# ADDENDUM NO. 3

**Perry Meridian High School Phase 2 Renovations  
401 W. Meridian School Road  
Indianapolis, IN 46217**

This Addendum consists of Pages ADD 3-1, Lancer Associates Architecture Addendum No. 3, dated September 17, 2026, consisting of six (6) pages, and Addendum 3 Drawings: C-7.1, C-7.3, C-7.4, PF101, PP101, P-601, P-901, P-903, ED108, EP101, EP108, E-701, A202, A751, & A753

**ADDENDUM NO. THREE**

6 INT. ELEV. - CHORAL 5C W  
SCALE: 3/8" = 1'-0" REF. 1 / A721H

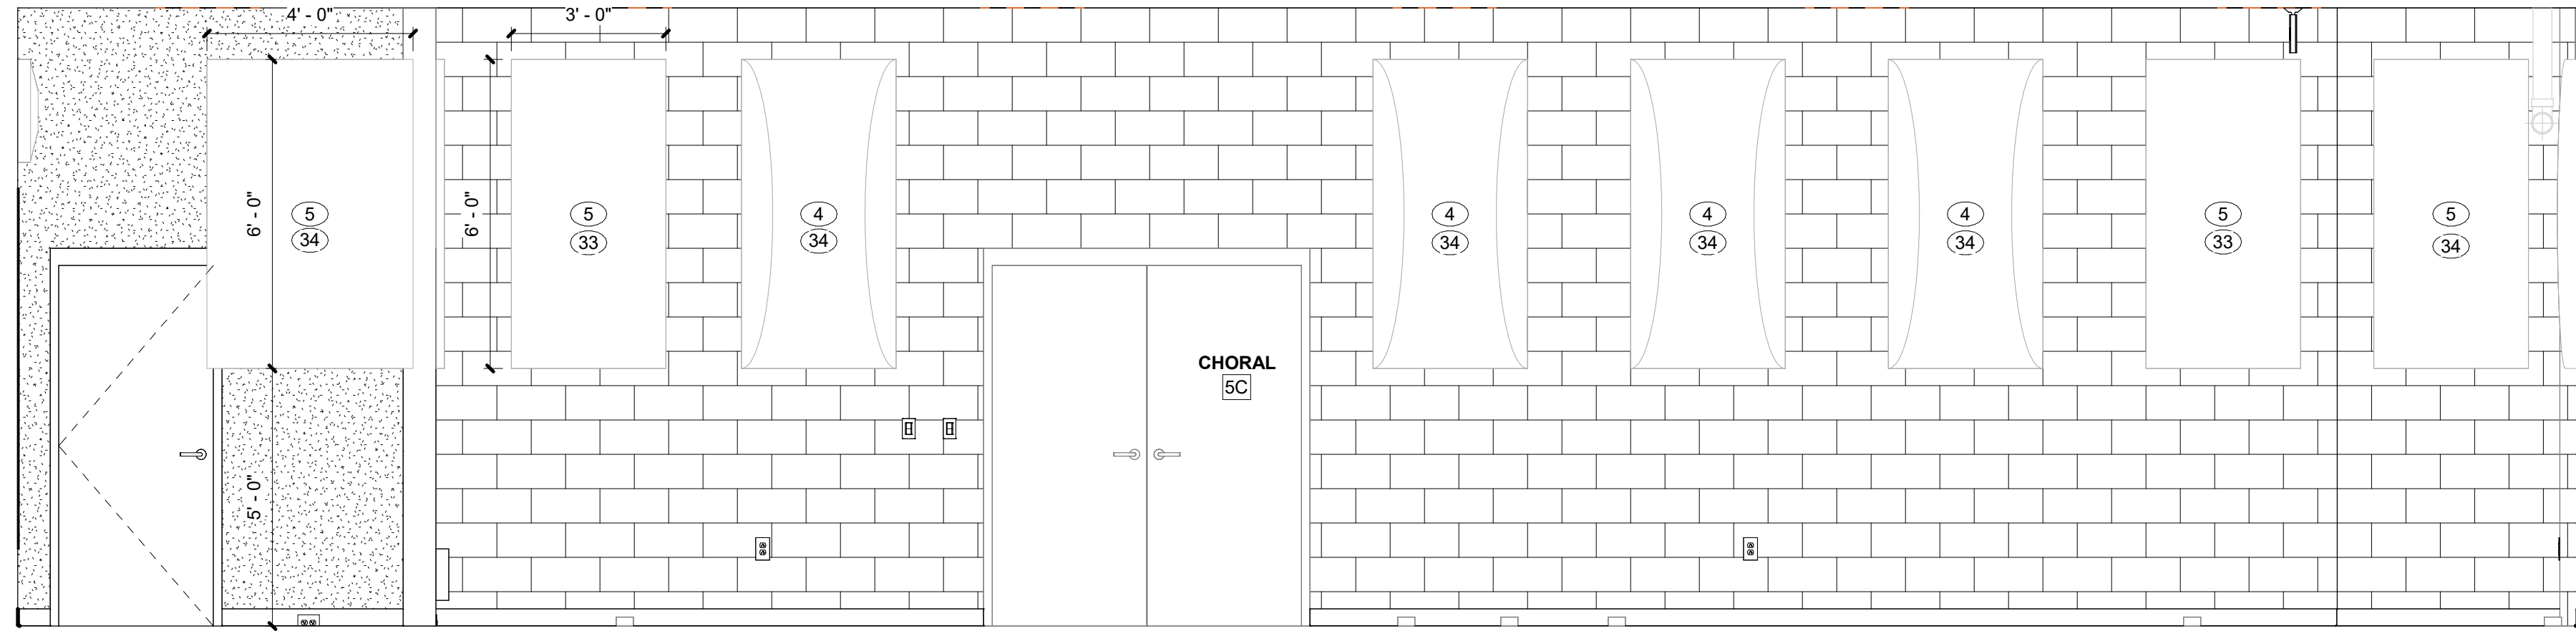
- 13. Sheet A751
  - a. Added acoustical wall panel fabric finish to 1/A751, 2/A751, 4/A751, and 5/A751.
- 14. Sheet A753
  - a. Added acoustical wall panel fabric finish to 2/A753, 3/A753, 5/A753, and 6/A753

1 ELECTRICAL POWER & SYSTEMS FIRST FLOOR PLAN - UNIT A  
1/8" = 1'-0"

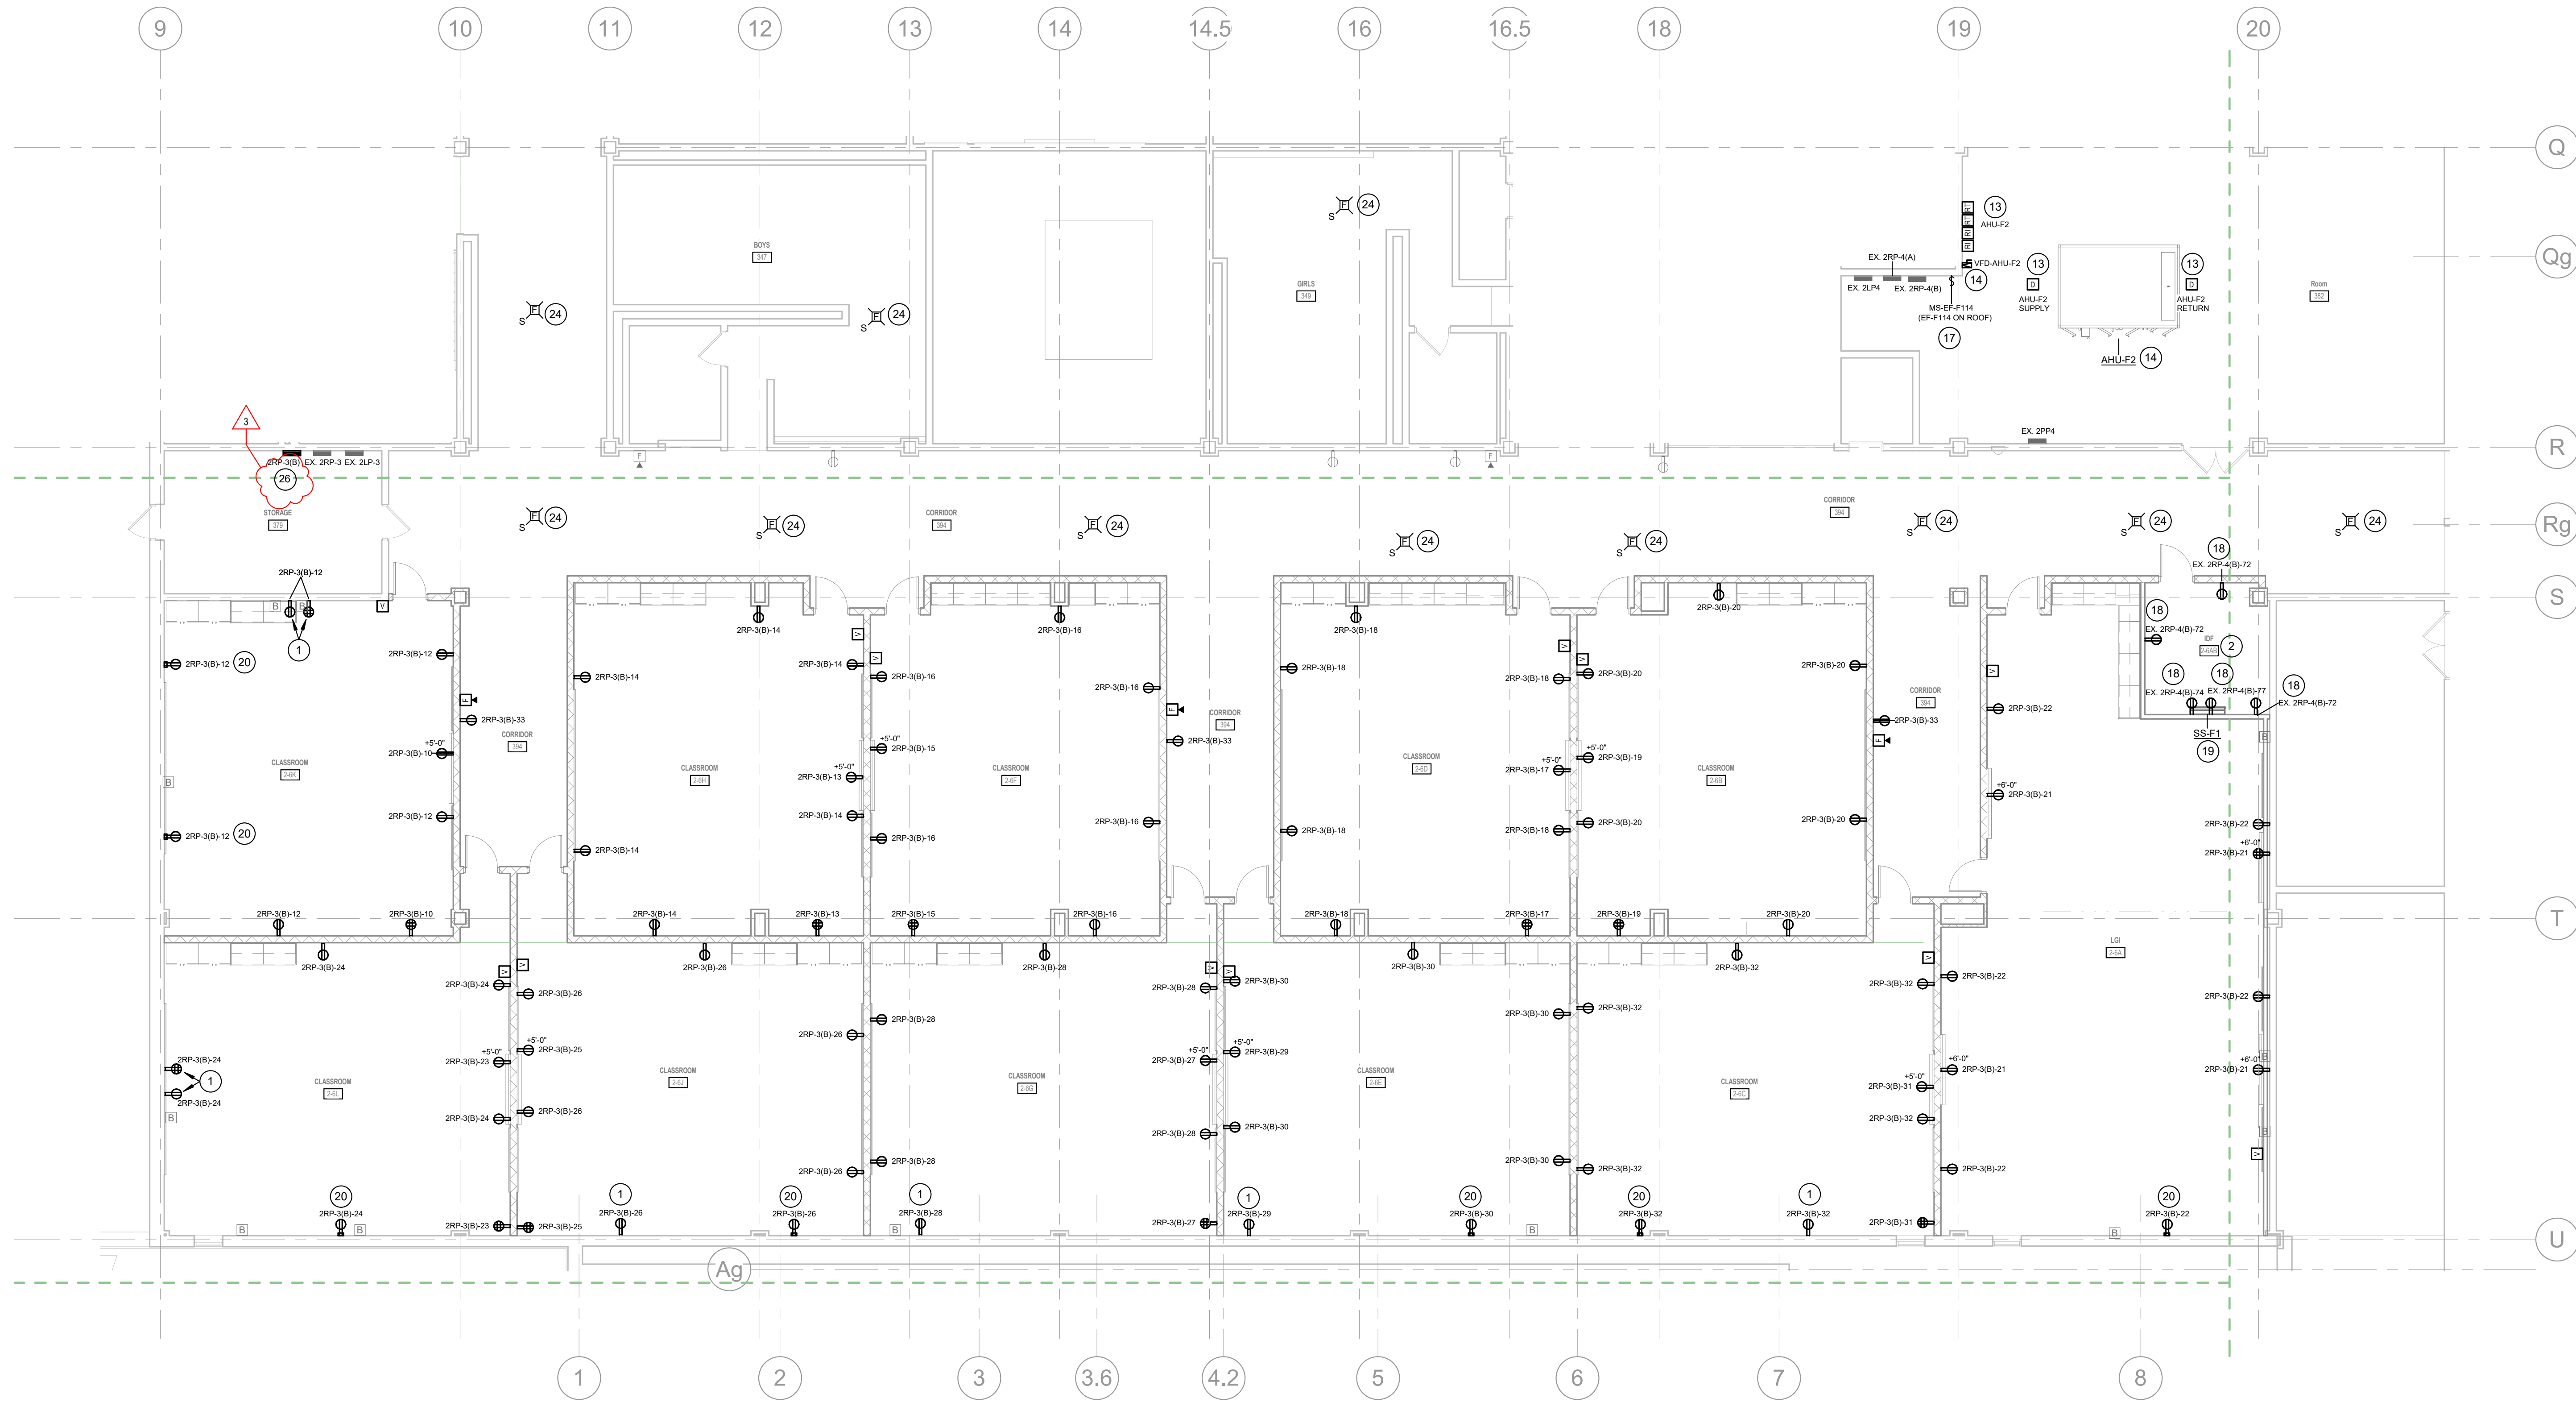
2. **Q:** Kiln Receptacles, 3D Art 12EC

- a. The plans show NEMA 15-50R (3-phase) receptacles on 2-pole circuits 1RP-6-56,58 and 1RP-6-60,62. What are the kiln electrical requirements?
- b. Voltage and phase
- c. Receptacle configuration
- d. Breaker poles and size
- e. Number of kilns (two receptacles are shown)

**A:** 3-pole circuit correction in addendum 3.

1 PARTIAL ONE-LINE DIAGRAMS  
NOT TO SCALE

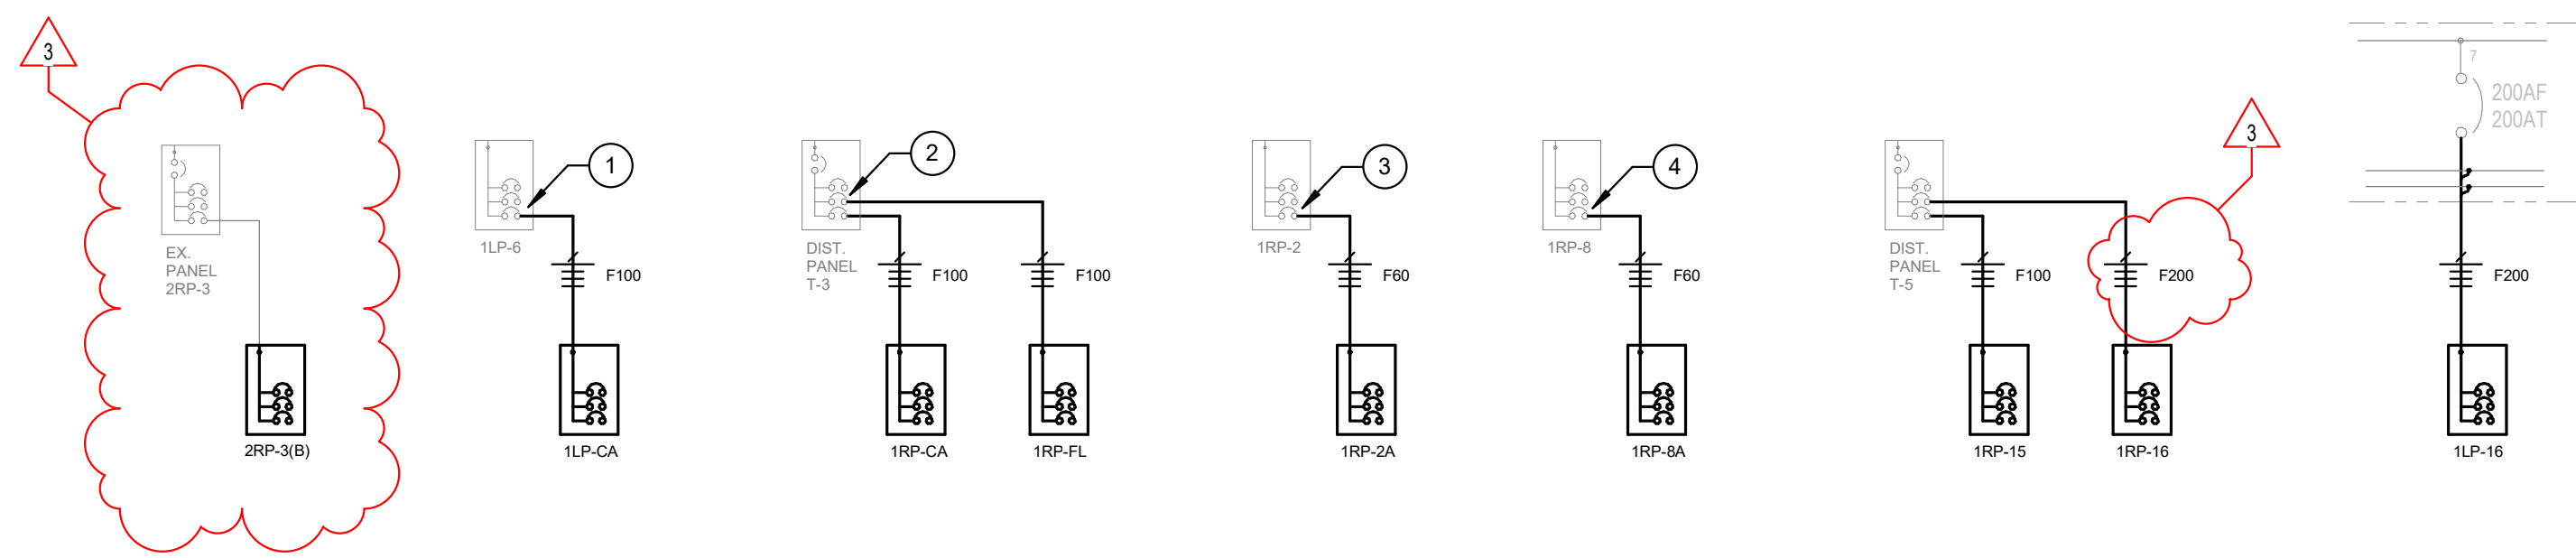
**8. Q:** Replacement Panels 1RP-15, 1RP-16 and 1LP-16

- a. Are the existing feeders to replacement panels 1RP-15, 1RP-16 and 1LP-16 reused, or replaced?
- b. 1RP-16 is scheduled as 225A MLO, but the one-line shows an F100 feeder from T-5. Which is correct?
- c. Where are MSB-1 and Distribution Panel T-5?

**10. Q:** "1RP-2-SUB" Reference

- a. E-701 note 3 relocates circuits to "1RP-2-SUB." Is this panel 1RP-2A?

**A:** Replace feeders per E-701. Feeder for 1RP-16 corrected to 200A in addendum 3. MSB-1 in main electrical room unit B (refer to addendum 3). T-5 located on mezzanine deck above panels, refer to ER103.

**A:** Correct. Note 3 reference updated in addendum 3.
